From: [Appel, Patrick](#)
To: [Coltrain, Katrina](#)
Cc: todd.downham@deq.ok.gov
Subject: RE: Wilcox Oil Treatability Study Work Plan Revision 00
Date: Monday, March 4, 2019 12:41:36 PM
Attachments: [image001.png](#)
[Wilcox Oil Treatability Study Work Plan Revision 0.1.pdf](#)

From: Coltrain, Katrina <coltrain.katrina@epa.gov>
Sent: Tuesday, February 19, 2019 11:15 AM
To: Appel, Patrick <pappel@eaest.com>
Cc: todd.downham@deq.ok.gov
Subject: RE: Wilcox Oil Treatability Study Work Plan Revision 00

Subject: Wilcox Oil Treatability Study Work Plan Revision 00

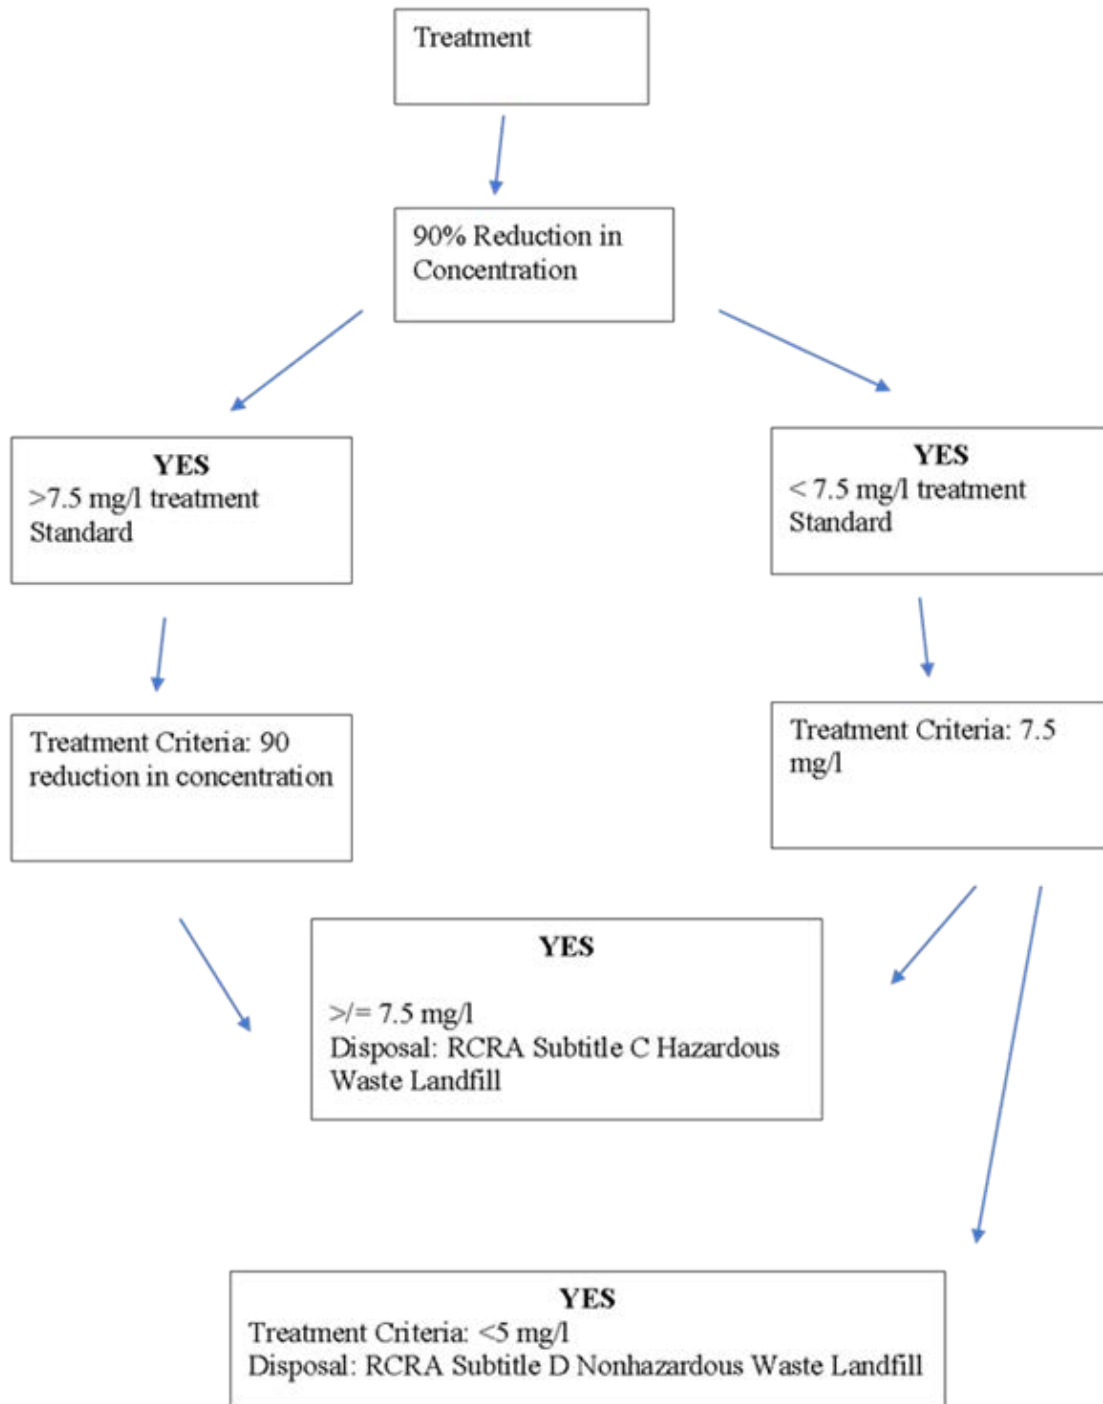
The regulations provide for alternative land disposal restriction treatment standards (268.49) that can be used to address soil contamination prior to disposal. For metals (i.e., lead), the treatment must achieve 90% reduction in constituent concentrations as measured by leachate data collected from the treated material or 90% reduction in total constituent concentration when a metals removal technology is used. The technology being used to treat the lead contamination is stabilization/solidification; therefore, the 90% reduction in constituent concentrations as measured by leachate data collected from the treated material criterion will be used.

The regulations further states that if treatment results in a 90% reduction constituent concentrations less than 10 times the treatment standard, then treatment need only meet the concentration that is 10 times the treatment standard (268.49(c)(1)(C)). For example, the treatment standard for lead is 0.75 mg/l in the leachate. The concentration that is 10 times this treatment standard is 7.5 mg/l lead in the leachate. If after treatment, the concentration is reduced by 90% and remains *above* 7.5 mg/l, treatment met a 90% reduction in concentration and the material can be disposed. If after treatment, the concentration is reduced by 90% and is *below* 7.5 mg/l, treatment exceeds the standard and only needs to meet 7.5 mg/l.

As noted in the previous paragraph, if the leachate exceeds 5 mg/l lead, then the material is considered a characteristic waste. Because 7.5 mg/l is above the characteristic criterion of 5 mg/l, the soil will need to be disposed at a RCRA subtitle C hazardous waste landfill even though it has been treated. Treating the waste to 5mg/l or less, will meet land disposal restrictions and allow for disposal at a RCRA subtitle D Nonhazardous landfill.

Hi Katrina- please see attached Revision 0.1 which incorporates your comments. Hopefully the waste classification meets our needs. I primarily used your explanation with a modified flow chart.
